**UT to Clarke Creek Stream and Wetland Restoration Site  
Annual Final Monitoring Report  
FINAL**

DMS # 92500

Monitoring Report Year 5 of 5  
Mecklenburg County, North Carolina

**Re: Comment Response Letter  
UT Clarke Creek Stream and Wetland Restoration  
DRAFT Monitoring Year 5 Report  
Yadkin River Basin – CU# 03040105  
Mecklenburg County  
DMS Project # 92500; DENR Contract No. 005363**

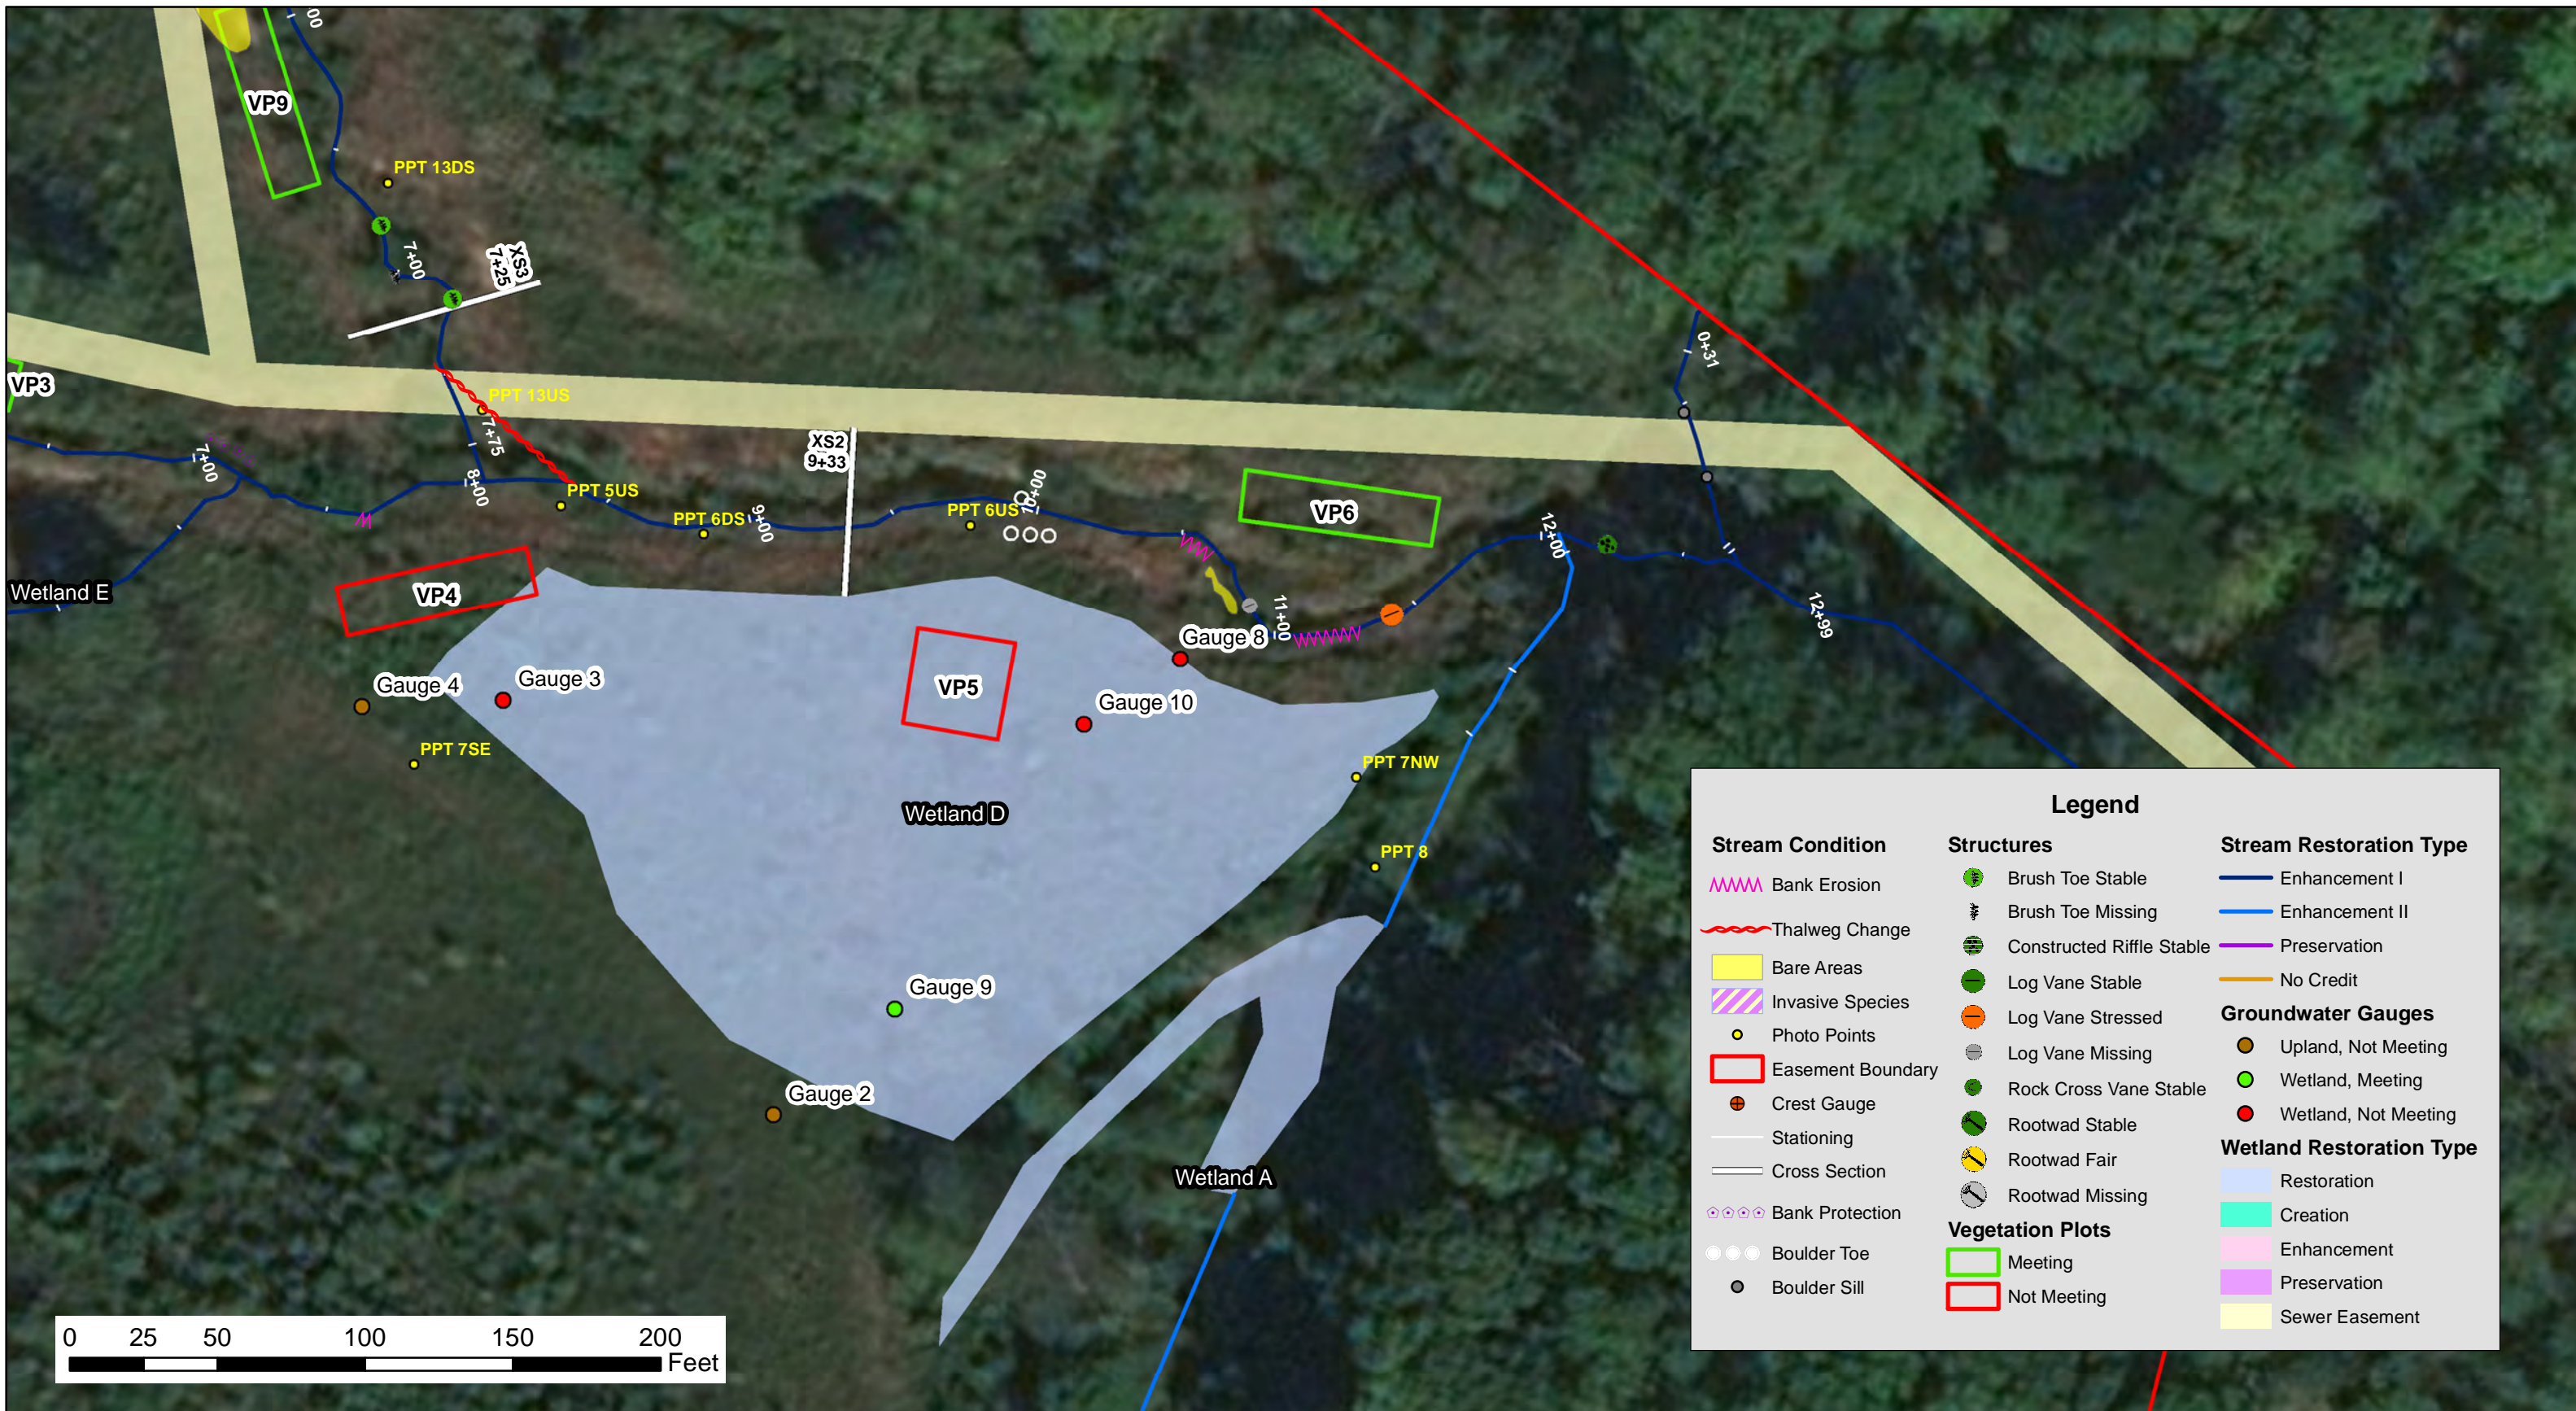
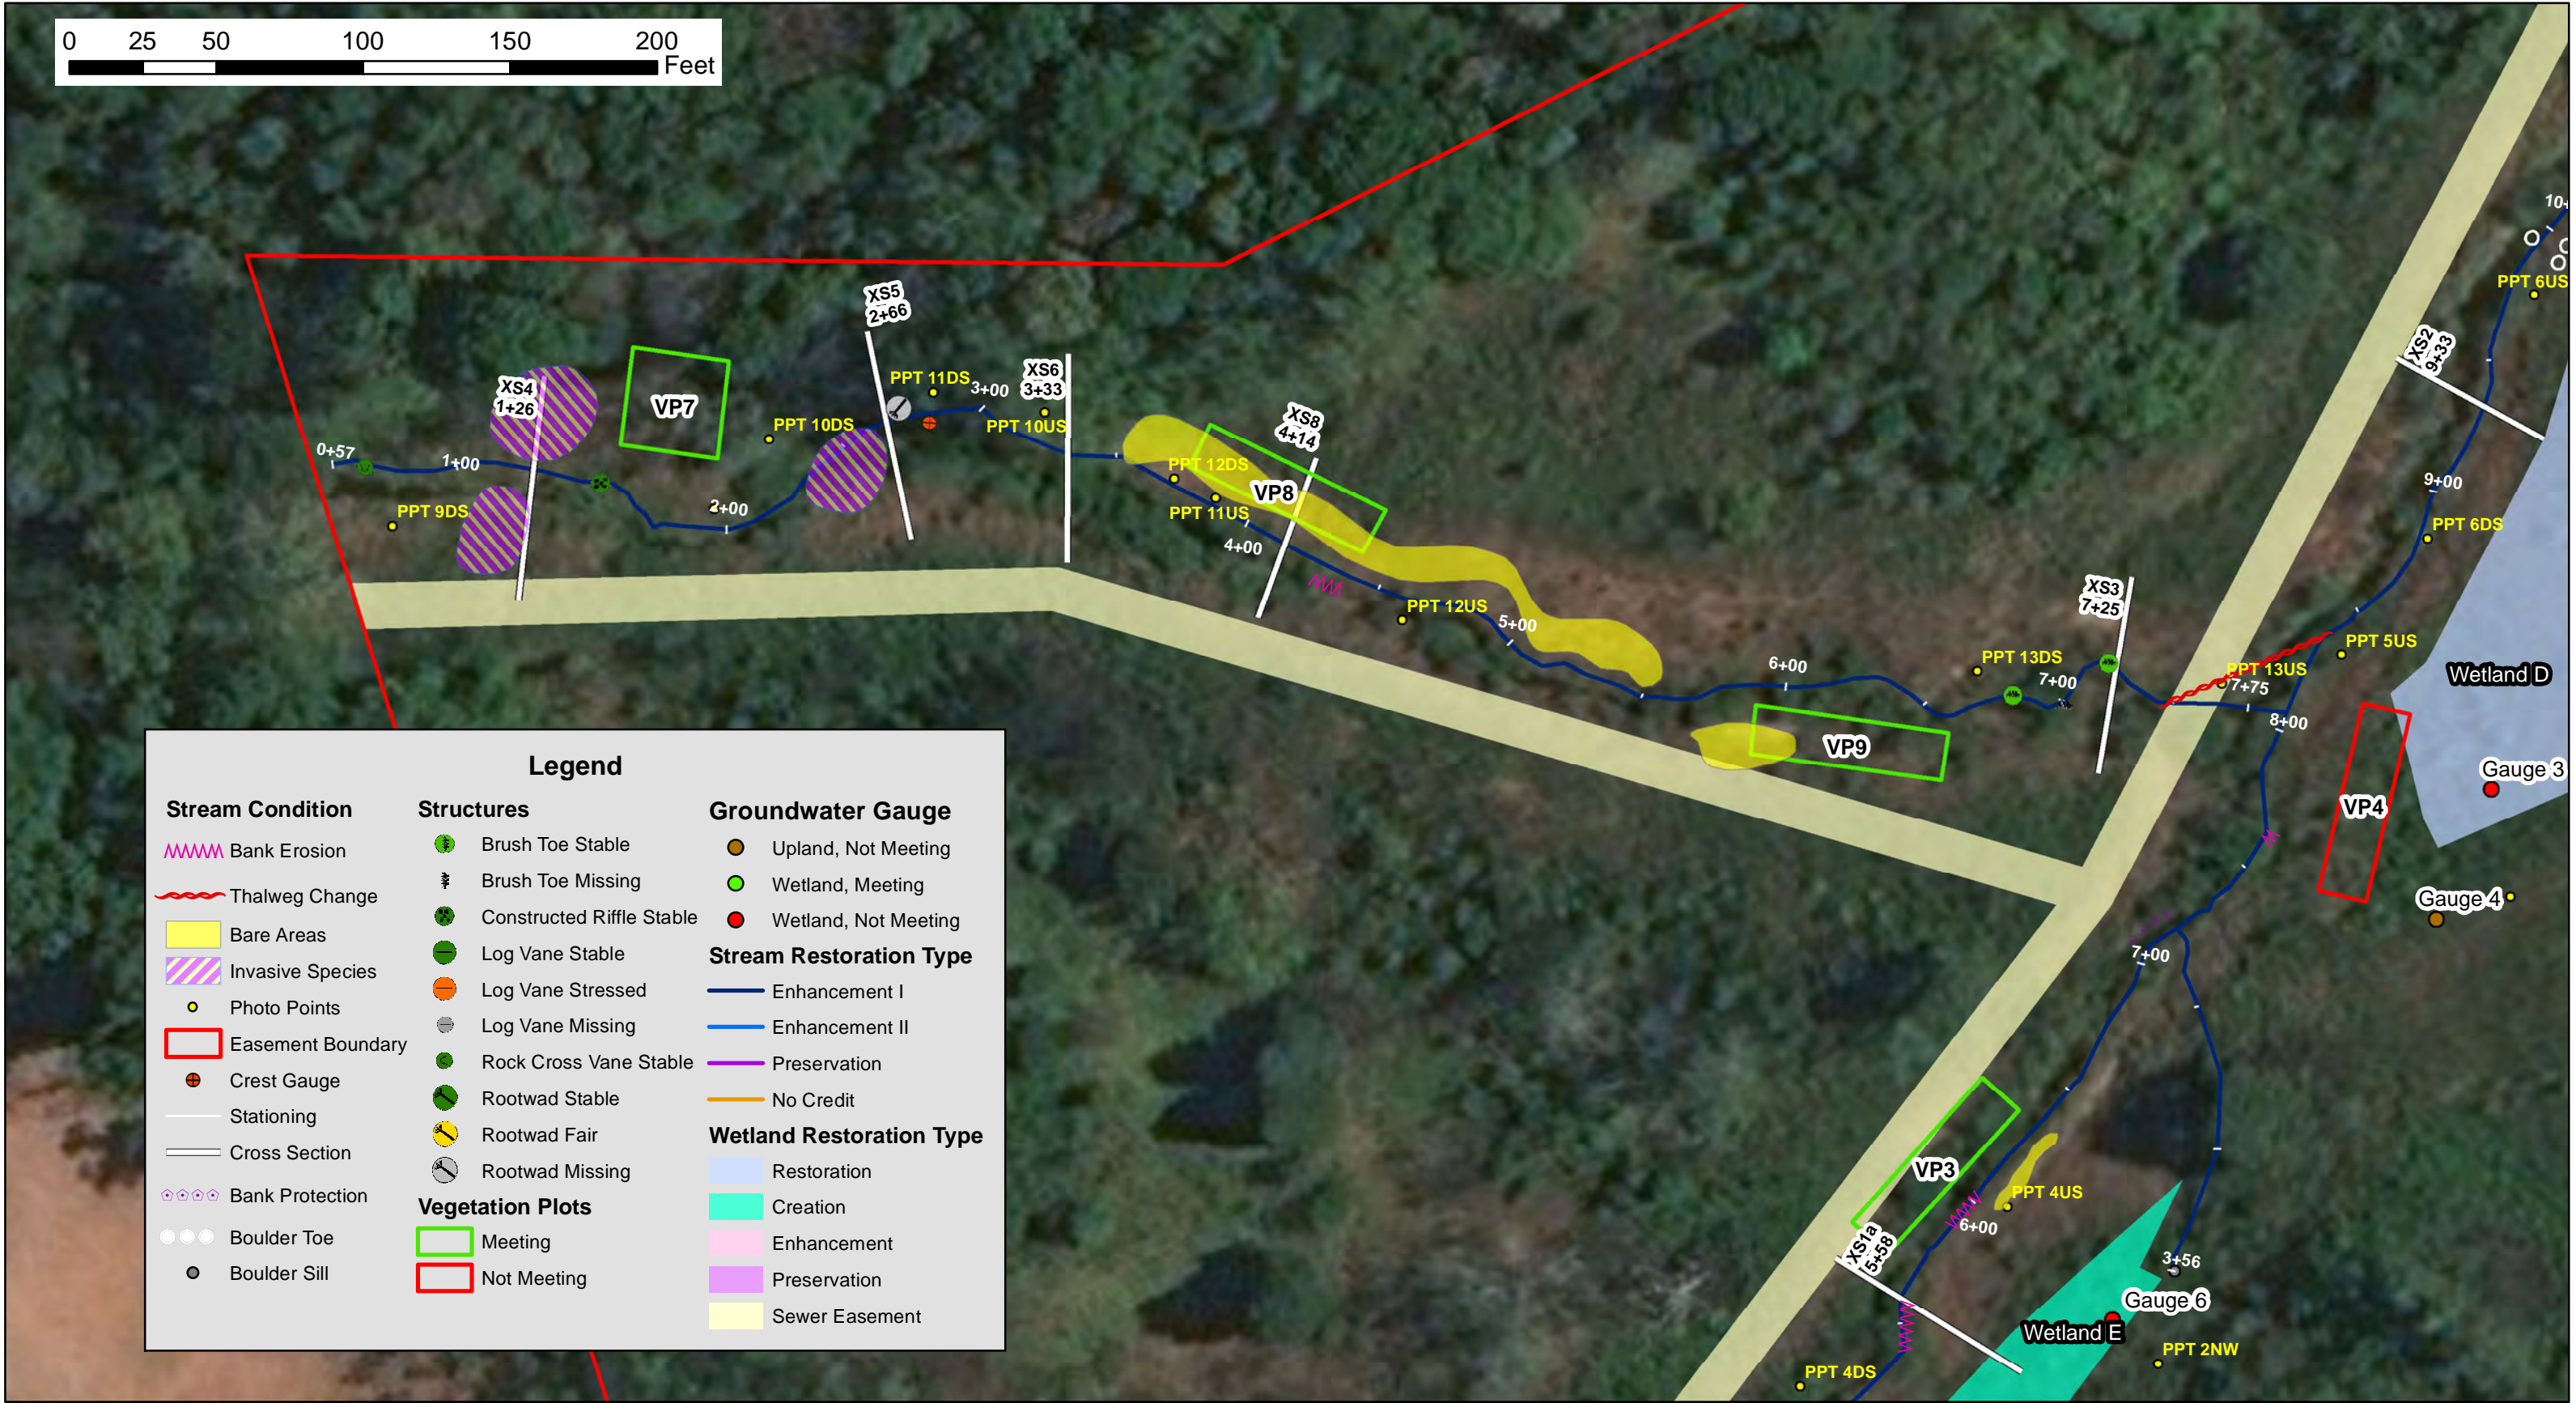
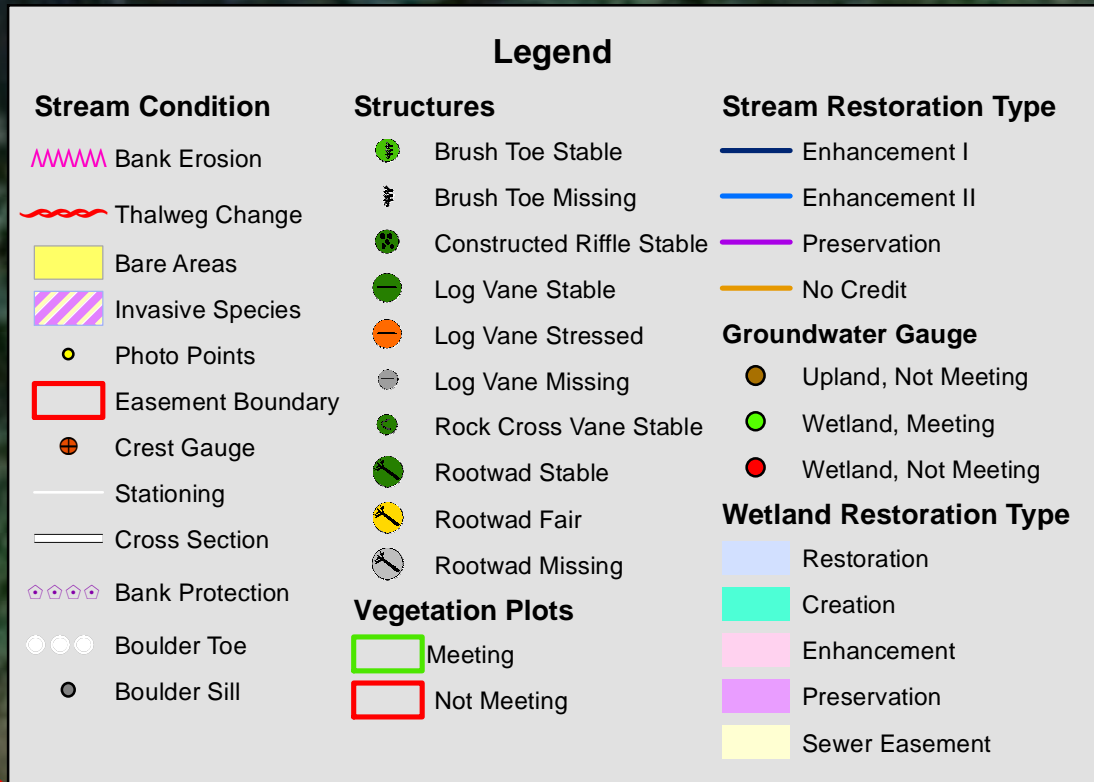
**Comment:** *CCPV Sheets: The "Wetland, Meeting" and "Wetland, Not Meeting" legend and map colors are similar. In the legend and mapping, please update "Wetland, Meeting" to green and "Wetland, Not Meeting" to red.*

**Comment:** *CCPV Sheets & Table 13: Based on Table 13, gauge 2 should be shown as an "upland" gauge on the maps. Additionally, gauge 8 should NOT be shown as a "upland" gauge on the maps. Please QA/ QA the Table and CCPV maps and update accordingly.*

**Comment:** *CCPV Sheets: For the vegetation plots, please update the "Meeting" legend and map color to green and the "Not Meeting" legend and map color to red.*

**Comment:** *CCPV Sheets and Table 6: Areas of invasive should be represented by general polygons (as reported in Table 6) and not points. Please update the CCPV maps accordingly. As noted in Table 6, the mapping threshold for invasive species is 1,000 square feet.*

**Comment:** *CCPV Sheets and Table 6: In the CCPV sheets, "Sparse Vegetation" should be changed. As reported in Table 6, "Bare Areas", "Low Stem Density Areas"; and Areas of Poor Growth Rates of Vigor" should be reported on the CCPV sheets. These areas should be represented by general polygons (as reported in Table 6) and not points or lines. Please update the CCPV maps accordingly. Please note the mapping threshold for these areas as established in Table 6.*

**Response:** The "Wetland, Meeting" symbol was changed to green and the "Wetland, Not Meeting" symbol was changed to red.

**Response:** Table 13 and the CCPV maps were reviewed. The CCPV map was revised, showing gauges 2, 4 and 7 as upland gauges.

**Response:** The "Meeting" symbol was changed to green and the "Not Meeting" symbol was changed to red.

**Response:** The CCPV was updated to depict invasive species as polygons. All invasive species points were removed.

**Response:** "Sparse Vegetation" was changed to "Bare Areas" in the CCPV sheets.

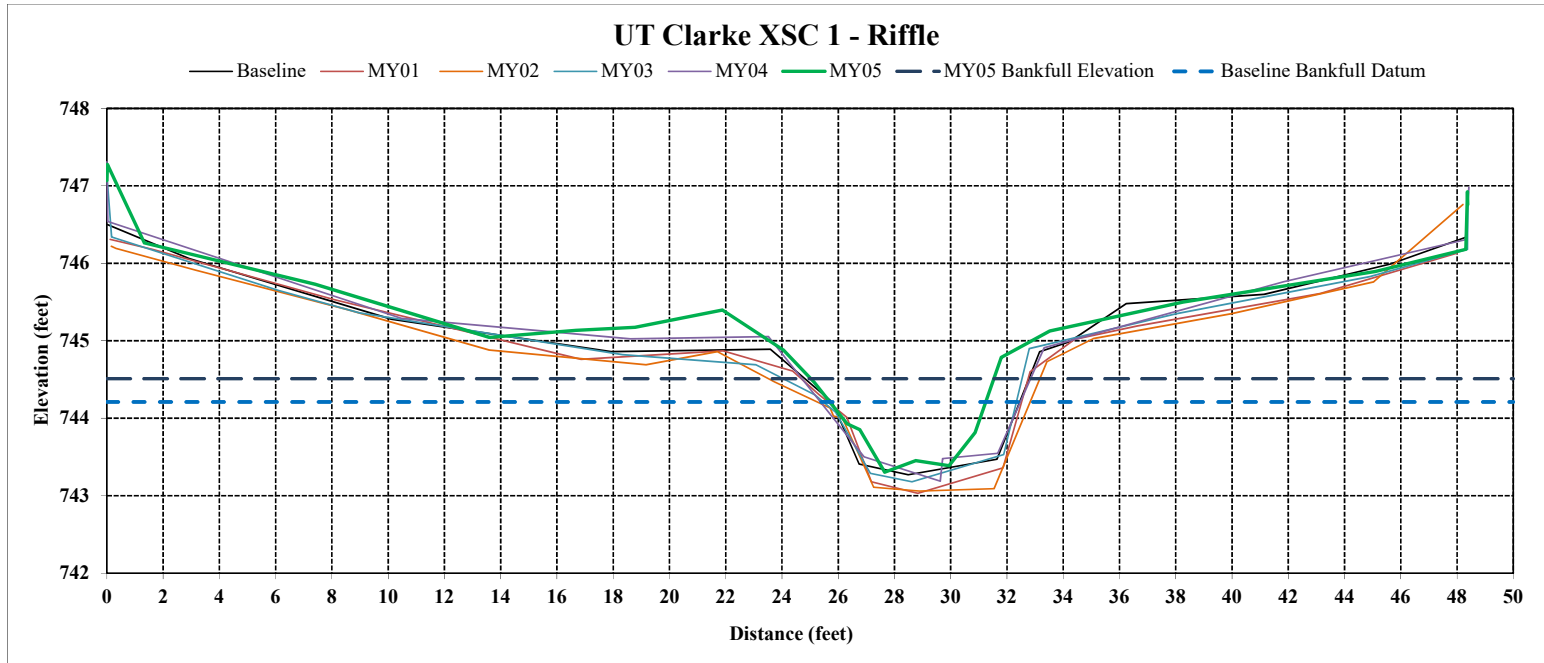
*The large change of BHR on XS1A and XS 9 appears visually inconsistent with changes seen in the graph. This may be an artifact of the new calculation method but appears questionable. Please verify the calculations (guidance attached).*

The large change in the BHR on XS1A and XS9 is mainly a result of the new BHR calculation method. The MY05 bankfull cross sectional area was revised to match the MY0 bankfull cross sectional area. This decreased the bankfull elevation, thereby decreasing the bankfull maximum depth, but the low bank elevation remained the same.

Cross Section 1A						
Monitoring Year	0 (baseline)	1 (2014)	2 (2015)	3 (2016)	4 (2017)	5 (2018)
Bankfull area (ft <sup>2</sup> )	1.78	5.96	7.67	7.92	7.5	1.8
Bankfull Elevation (ft)	742.4	742.4	742.4	742.4	742.4	741.8
Thalweg Elevation (ft)	740.92	740.48	740.59	740.74	740.68	740.98
Bankfull d max (ft)	1.48	1.92	1.81	1.66	1.72	0.8
Low Bank Elevation (ft)	742.93	743.04	742.65	742.89	743.14	743.14
Low Bank Height (ft)	2.01	2.56	2.06	2.15	2.46	2.2
BHR	1.4	1.3	1.1	1.3	1.4	2.8

On Cross Section 1A the bankfull elevation was lowered approximately 0.6 feet to adjust the MY05 bankfull cross sectional area to match the MY0 bankfull cross

sectional area. This reduced the bankfull maximum depth by 0.9 feet. The low bank height remained relatively consistent through the monitoring period (2.01 – 2.46 feet). The significant reduction in bankfull maximum depth and stable low bank height resulted in a significantly higher MY05 BHR.
